WATER PERMIT NO. 6314-3

Name of Applicant: Wild Oak Golf Club

**SOUTH DAKOTA
WATER PERMIT NO. 6314-3**

WILD OAK GOLF COURSE ADDITION PROPOSED DAM STRUCTURE MITCHELL, SOUTH DAKOTA

Sheet Name:
**Dam Structure
Overall Plan**

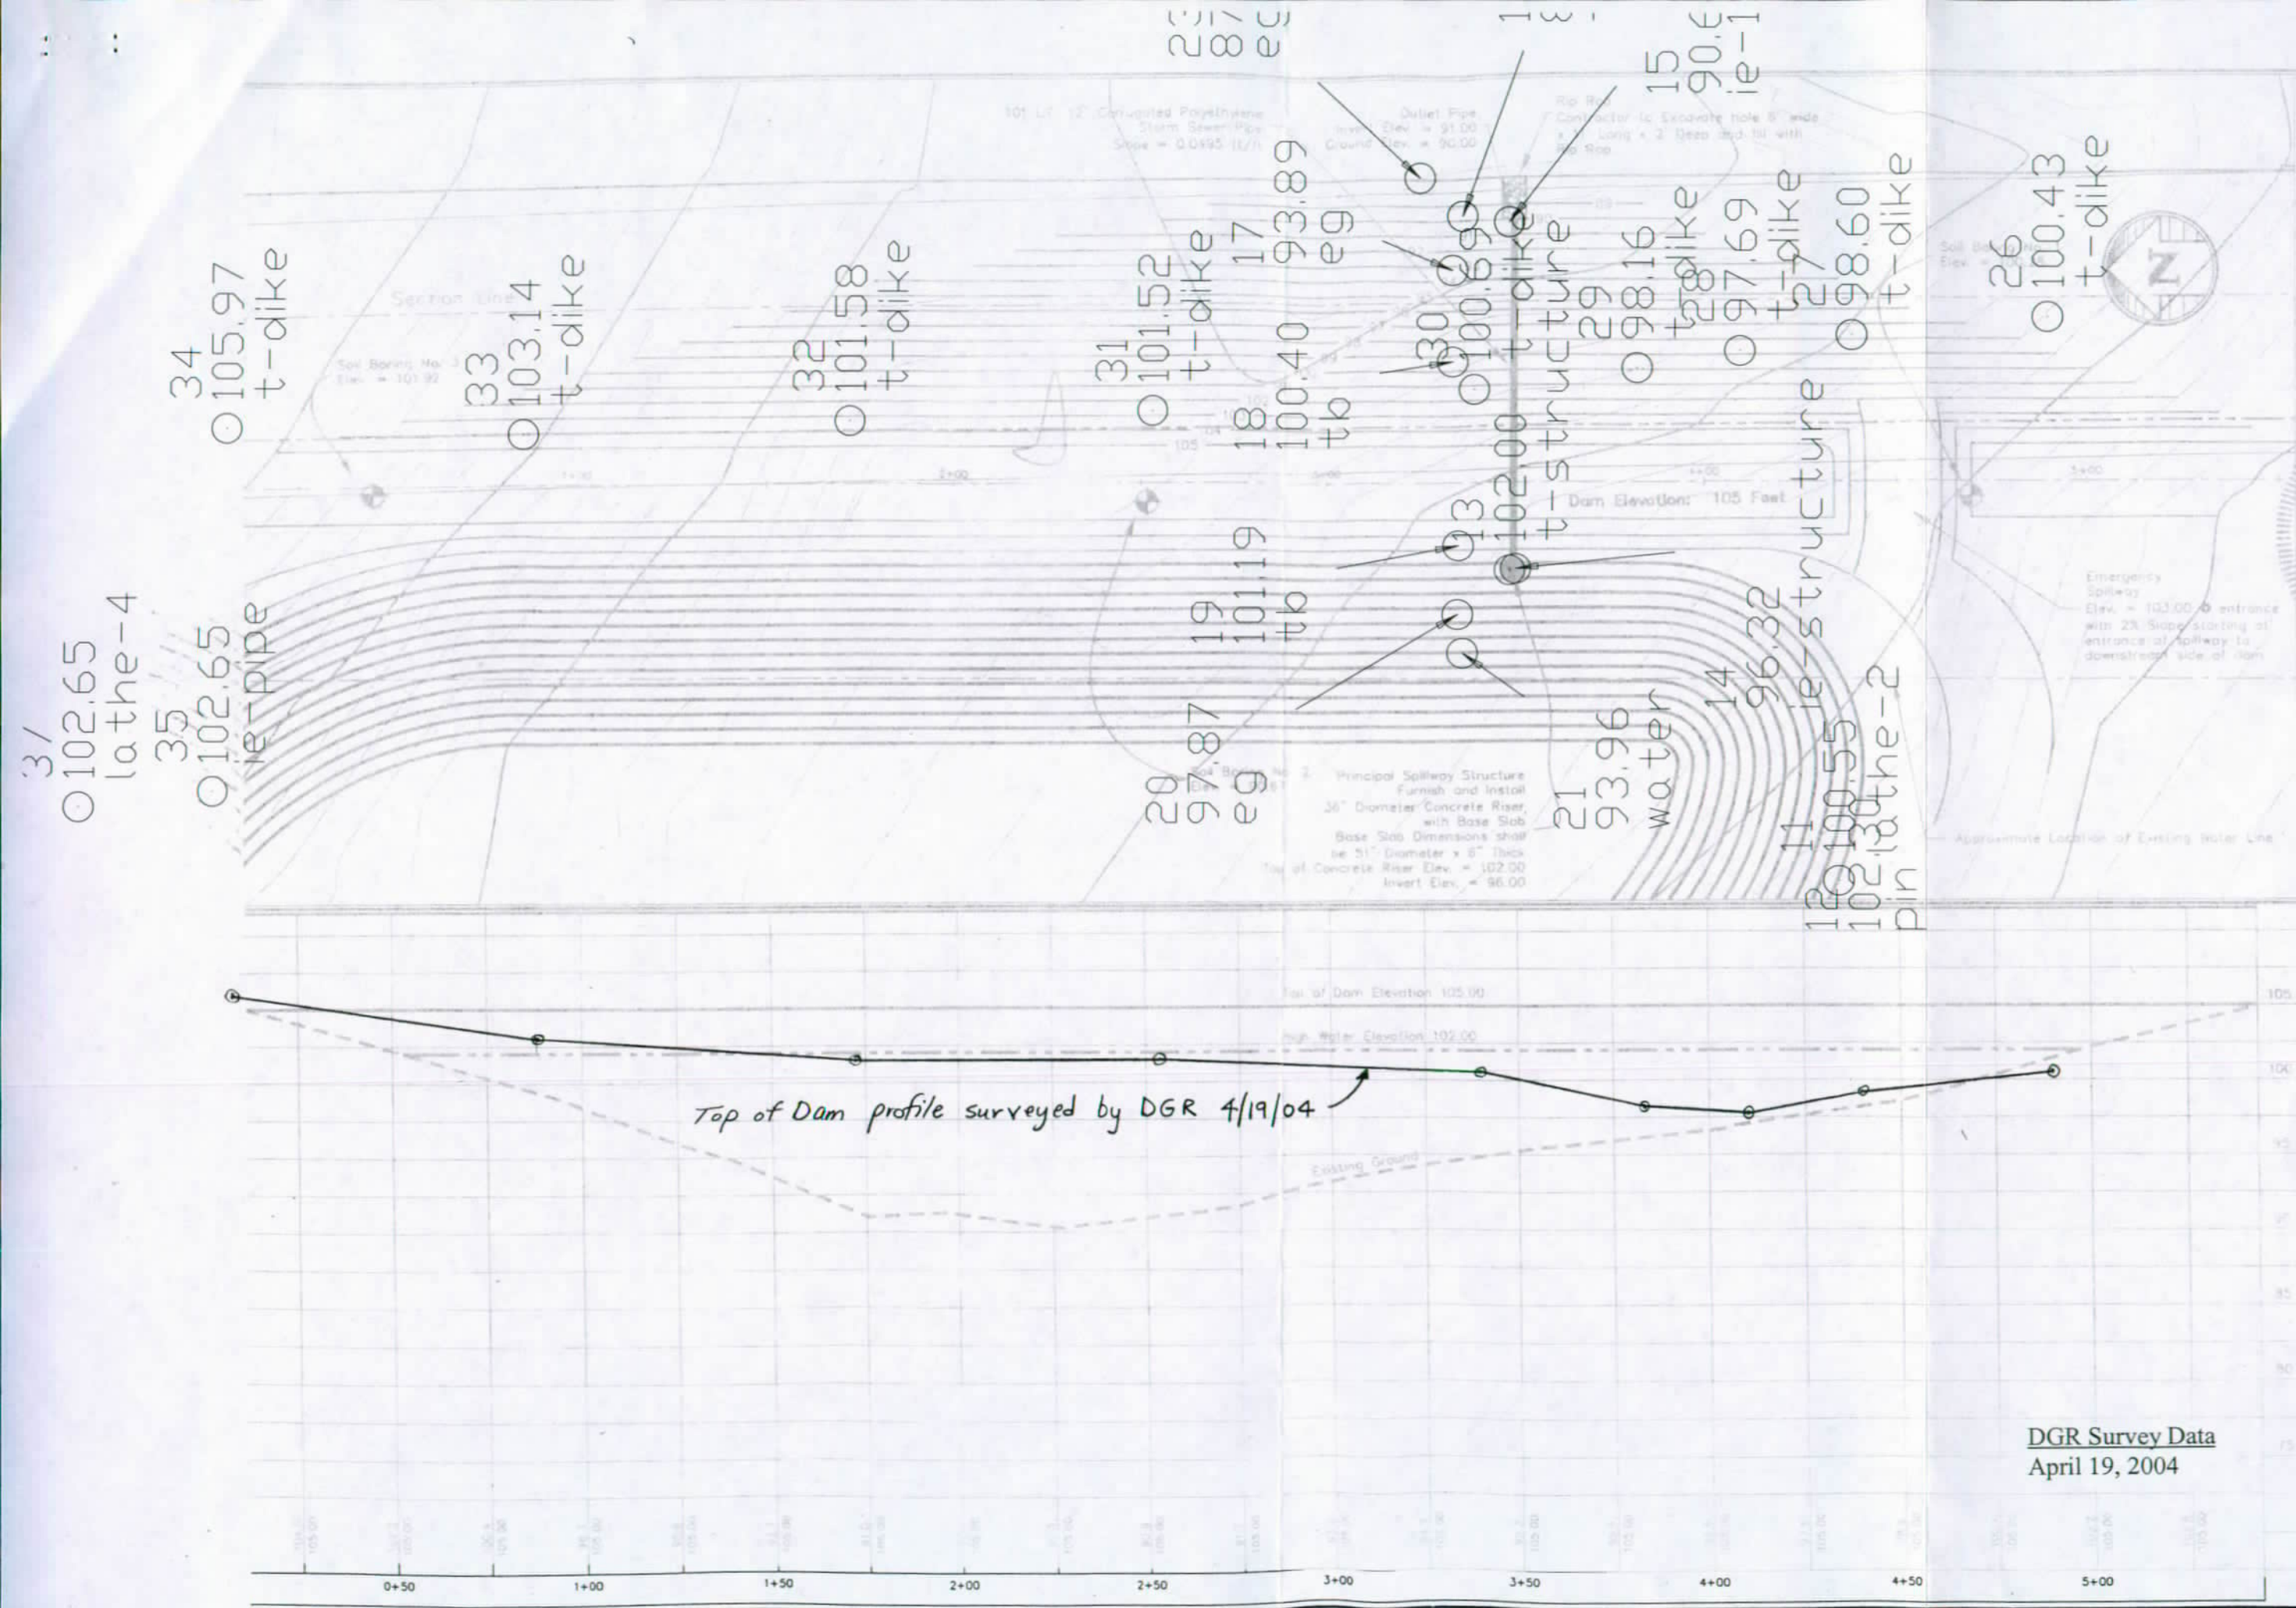
1. The bench mark elevation shown on Sheet 2 of the drawings and described as "BM Concrete Post Elev. 108.5 Feet" represents the approximate ground elevation at the base of this concrete highway right-of-way post, which was most likely estimated from the one-foot contours shown on this plan sheet. We initially assumed this elevation to be on the top of the post, which we discovered during our survey did not agree with the contour elevations on the project drawings. Since the ground around the post was not level and the elevation only estimated, we chose to use the top of the 36-inch diameter concrete riser which Mr. Backlund reports was constructed to the elevation 102.00 feet staked by SPN Associates for this riser. Using the top of the riser as elevation 102.00 feet as the bench mark, we found that the contours downstream of the dam agreed with this datum and that the elevation of the top of the concrete post indicated as the bench mark is 112.01 feet.

4. The locations surveyed for the five remaining original stakes set by SPN Associates are shown as "lathe-1" through "lathe-5" inclusive on our overlay to Sheet 2 of the project drawings. Our location survey indicates that these stakes were set on or near the 102-foot contour line shown on Sheet 2 of the project drawings. At lathe-4 and lathe-5, the ground elevation is close to the 102-foot contour line. At lathe-1, lathe-2, and lathe-3, the ground elevation is slightly lower or higher than the 102-foot contour line. The markings on all five stakes were mostly faded away. All of the stakes appear to have been marked with the words "Top Lake". Lathe-2 had faint markings which appeared to be "F1x70". The rest of the markings on the stakes were too faded to read.

**DGR Survey Data
April 19, 2004**

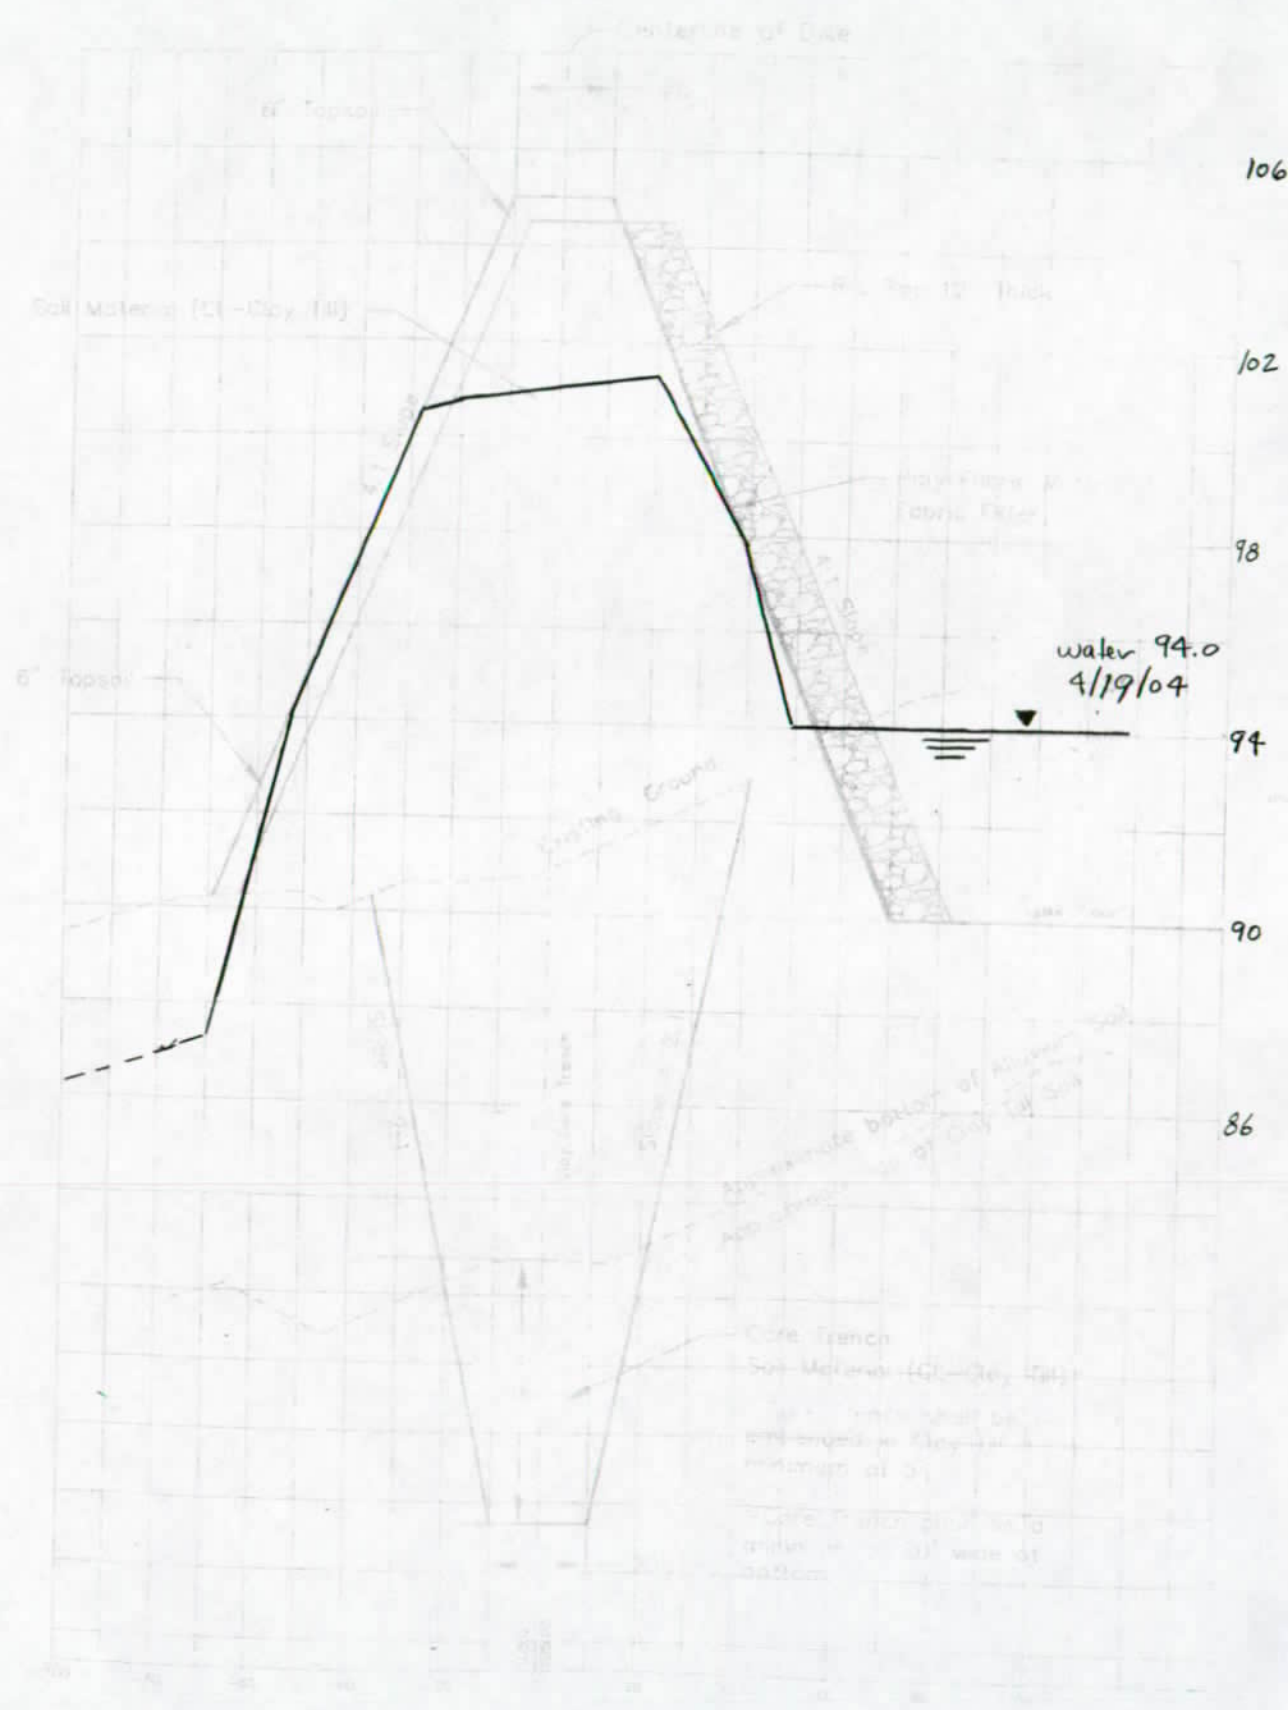
Existing Conditions. Since the dam was originally constructed, Mr. Backlund reports that he had the top of the dam lowered. The profile shown on our overlay on Sheet 3 of the drawings indicates the elevation profile of the existing top of the dam as surveyed on 4/19/04. This profile shows that the lowest point in the top of the dam profile is about 100.5 feet and the lowest point in the emergency spillway crest is about 97.7 feet. The original top of dam width was designed at 20 feet at elevation 105.0. The existing top of dam as it has been cut down has a top of dam width of about 50 feet. The top of the concrete riser pipe is too high to function to drain flood runoff from the lake, and needs to be lowered by 4.5 feet to 97.5 feet. The upstream face of the dam and lake shoreline need to be riprapped to address major erosion problems with the clay soils, which are highly erodible. The downstream face of the dam, the top of the dam, and all disturbed area above the riprap line needs to be topsoiled and revegetated with grass in such a manner to stabilize the slopes and minimize erosion. The 6" PVC pipe which inputs water pumped from the Firesteel Creek pump station is now at an elevation of 102.65 feet. This pipe could be lowered about 4.5 feet to an inlet elevation of about 98 feet.

Typical Dam Cross Section

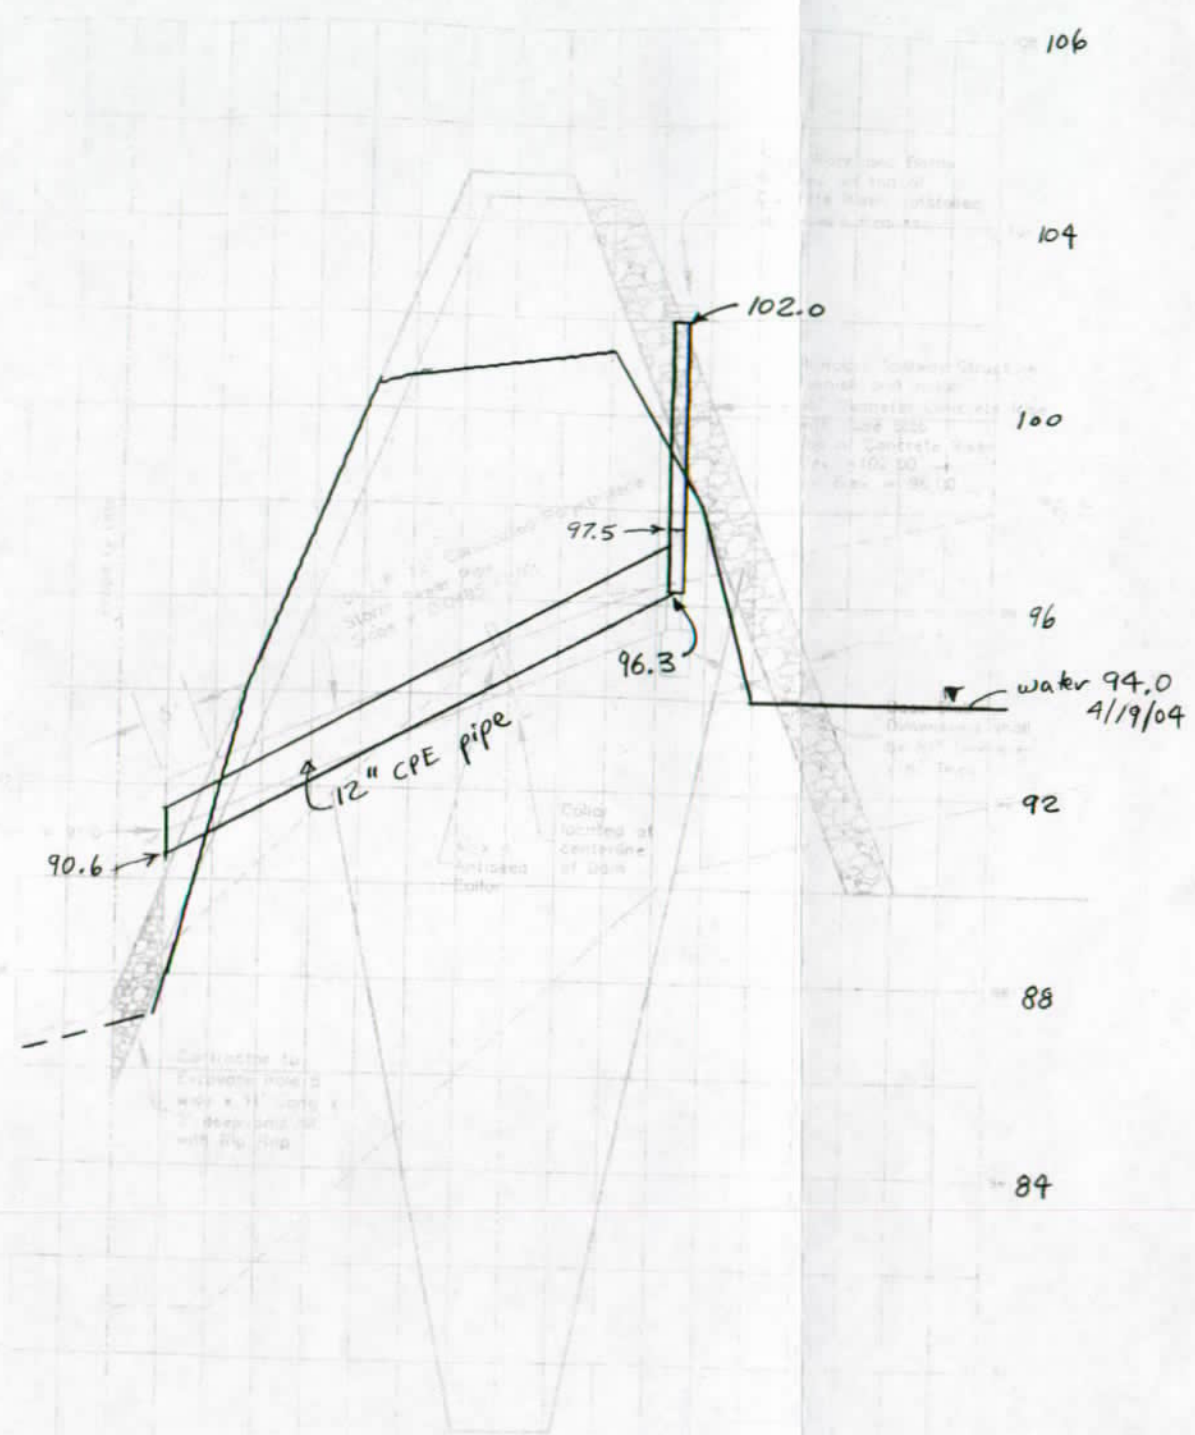
3. We surveyed a cross section of the dam approximately 15' north of the concrete riser pipe. This cross section is shown on our attached overlay to Sheet 4 of the project drawings. As can be seen on this overlay, this cross section fits well with the originally designed dam cross section, except that the top 4 feet of the dam has been removed. Mr. Backlund reports and the photographs furnished to us verify that the dam was originally constructed to the 105.0 feet plan elevation shown on the project drawings. Mr. Backlund reports that he subsequently cut the top of dam down to mitigate his fears of possible upstream flooding by this dam at this elevation.
